Wisconsin Department of Transportation

Proposal #04: 5436-00-75, WISC 2025303
Town of Barre – Town of Bangor
Russlan Coulee CRK Bridge B-32-0239
CTH M
La Crosse County

This is Addendum No. 02, which provides for the following:

STRUCTURE B-32-239

TYPICAL SECTION,
 QUANTITIES
 AND NOTES

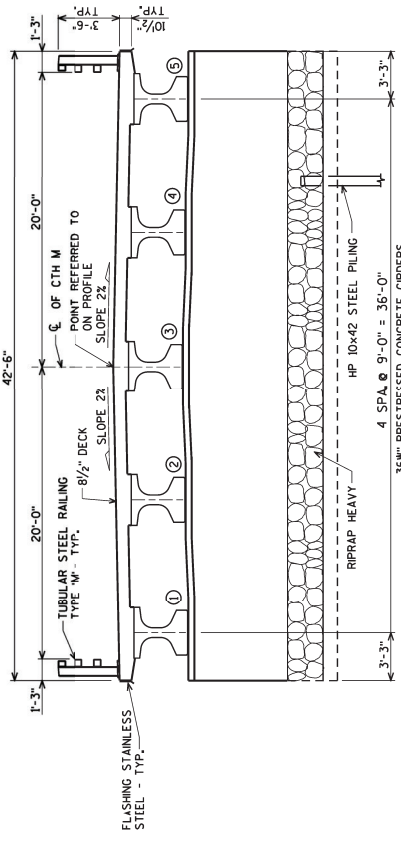
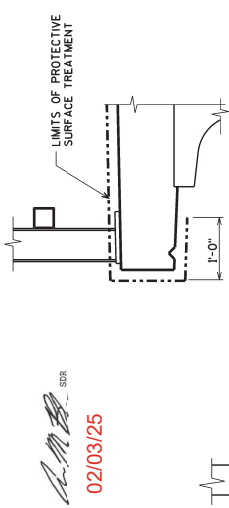
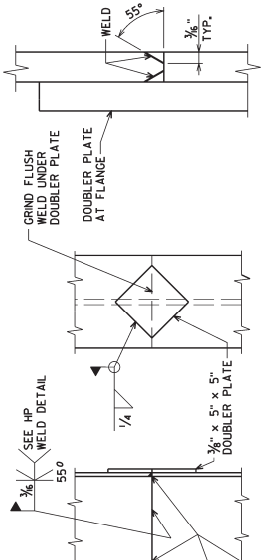
Revised Plan Sheets	
Plan Sheet	Plan Sheet Title (brief description of changes to sheet)
54	Structure B-32-239 Typical Section, Quantities and Notes Plan: Added Seismograph and Crack and Damage Survey to quantities table

NO.	DATE	REVISION	BY
Δ 02/03/25		UPDATE TO QUANTITIES	AYRES

999.1001.S	SET/GRAPH 5436-00-75	EACH	-----	-----	-----	1	1	-----
999.1501.S	CRACK AND DAMAGE SURVEY	EACH	-----	-----	-----	2	2	-----
SPV-0090-01	REMOVING EXISTING TIMBER PILING	LF	176	-----	-----	176	176	-----
	NON-BID ITEMS	SIZE	-----	-----	-----	1/2" & 3/4"	-----	-----
	FILLER	-----	-----	-----	-----	-----	-----	-----
